**17-157 Log #2543a NEC-P17 Final Action: Reject
(682.2.Equipotential Plane)****Submitter:** William Gross, Electric Service of Clinton**Recommendation:** Add new text to read as follows:

Number Eligible to Vote: 9**Ballot Results:** Affirmative: 9**ARTICLE 690 — SOLAR PHOTOVOLTAIC (PV) SYSTEMS****4-167 Log #3418 NEC-P04 Final Action: Accept in Principle
(690.X (New))****Submitter:** Joerg Grosshennig, SMA Solar Technology AG**Recommendation:** Add text to read as follows:**690.XX Utility-Interactive Photovoltaic Systems on Buildings Response to Emergency Shutdown.**

Figure 690.1(A) Identification of Solar Photovoltaic System Components.

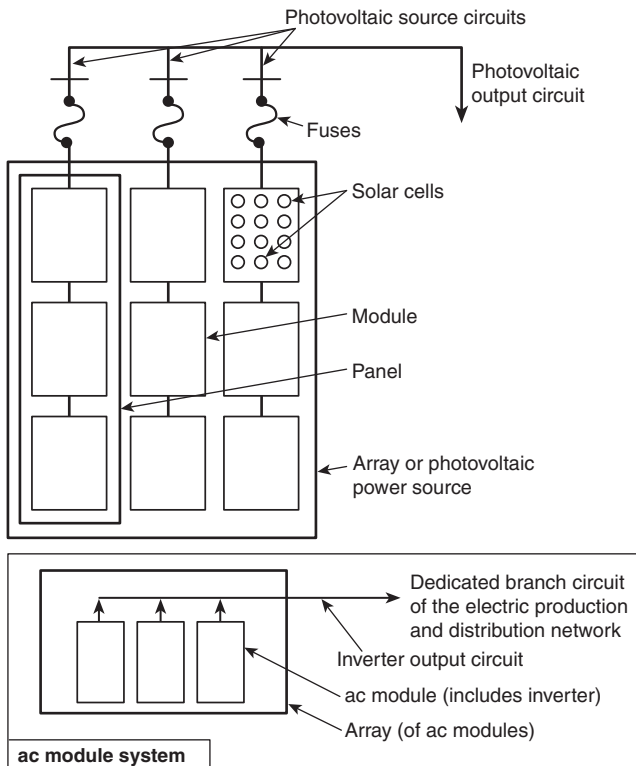
Number Eligible to Vote: 13**Ballot Results:** Affirmative: 13**4-169 Log #543 NEC-P04 Final Action: Reject
(Figure 690.1(A))****Submitter:** Philip Heim, Local 343 IBEW**Recommendation:** Reverse direction of Blocking Diodes so that photovoltaic output flows from fuses into arrowhead of divides.

Substantiation: I was taught that current flows is passed by a diode when current flows into the arrowhead (marked end of a divide) and current is blocked from the opposite direction. As diagramed current flow would be blocked from flowing out of the solar cells.

Submitter: John C. Wiles, Southwest Technology Development Institute, New Mexico State University / Rep. PV Industry Forum
Recommendation: Remove the blocking diodes from the diagram as noted below.

Substantiation: Some AHJs view the blocking diodes as mandatory since this figure is not in an Annex or Informative Note as required by the NEC Style Manual for non mandatory material. Blocking diodes are no longer used in PV arrays and to keep them in the diagram may be confusing. They are a hold over from systems of the 1970s and 1980s before the NEC and UL standards required fuses to protect PV conductors and PV modules.

Panel Meeting Action: Reject

Panel Statement: The substantiation is technically incorrect. See panel action on Proposal 4-170 where the diodes have been removed from the figure.
